Staff Report – Jerome Township (U) Zoning Amendment

| Request: | <p>The Zoning Commission received an application to rezone three parcels totaling 23.36 +/- acres. The proposal would rezone the acreage from Rural Residential District (RU) to a Planned Development District (PD).</p> <p>Parcels involved:</p> <ul style="list-style-type: none"> • 1700110330000 • 1700110344000 • 1700110345000 <p>Existing Use:</p> <ul style="list-style-type: none"> • “2 existing homes to remain” • The Auditor’s Office notes these are single-family dwellings <p>Proposed Uses:</p> <ul style="list-style-type: none"> • Dwellings, Detached Single-family (2.0 dwelling units per gross acre maximum) • Open space areas, multi-use paths, ponds and stormwater facilities. • Community facilities such as clubhouses, swimming pools, outdoor and recreational activity areas and seating including, community gardens and common mail/parcel facilities/structures. • Accessory uses as may be permitted under the regulations provided for in Chapter 645 of the Zoning Resolution. • Limited home occupations as provided for in Chapter 635 of the Zoning Resolution. • Temporary uses, including multiple temporary real estate sales off

Figure 4: Tree Masses (Jerome Plan, pp.6-3)

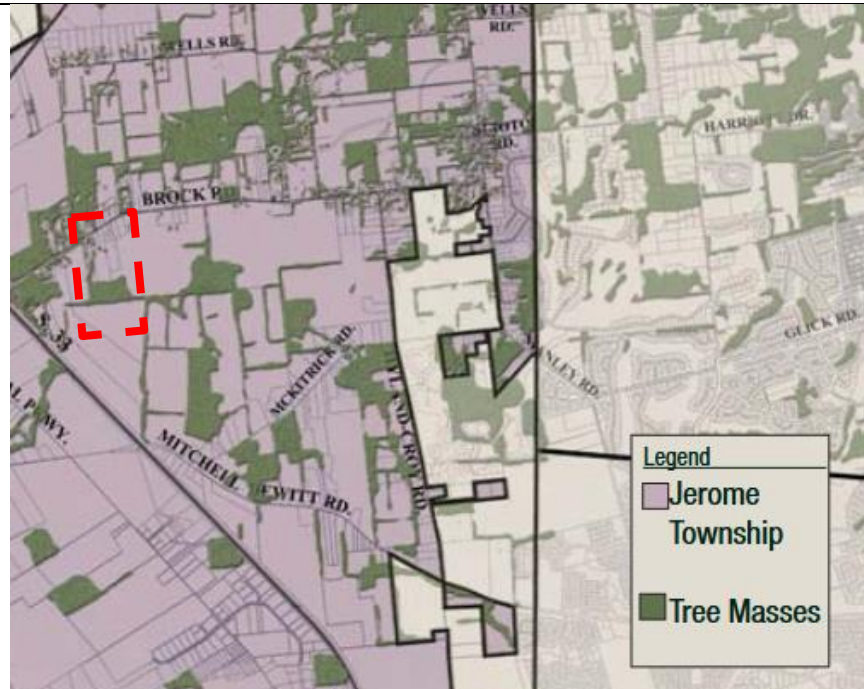
After reviewing the conceptual plan, LUC Staff wonders how residential uses are being clustered “for the purpose of preserving large areas of open space and/or significant natural features” (Jerome Plan, 6-8). In its current iteration, the conceptual plan indicates the pond will be reduced in size and the tree stand located on the back 1/3 of the property will be converted to residential lots, right-of-way, and open space. The open spaces at the rear of the property does not appear large enough to meet the minimum criteria required by the Township to qualify in the open space minimum required in the Zoning Resolution (ZR, 5-9).

Recommendation 2: LUC Staff recommends the Township consider how more trees at the rear of the property can be preserved. The Residential Conservation District reads, “Depending on the design and the natural features of the site, density can range between 1 and 2 units per gross acres with 2 being the maximum density recommended” (Jerome Plan, pp. 6-8). This should influence the density of the PUD.
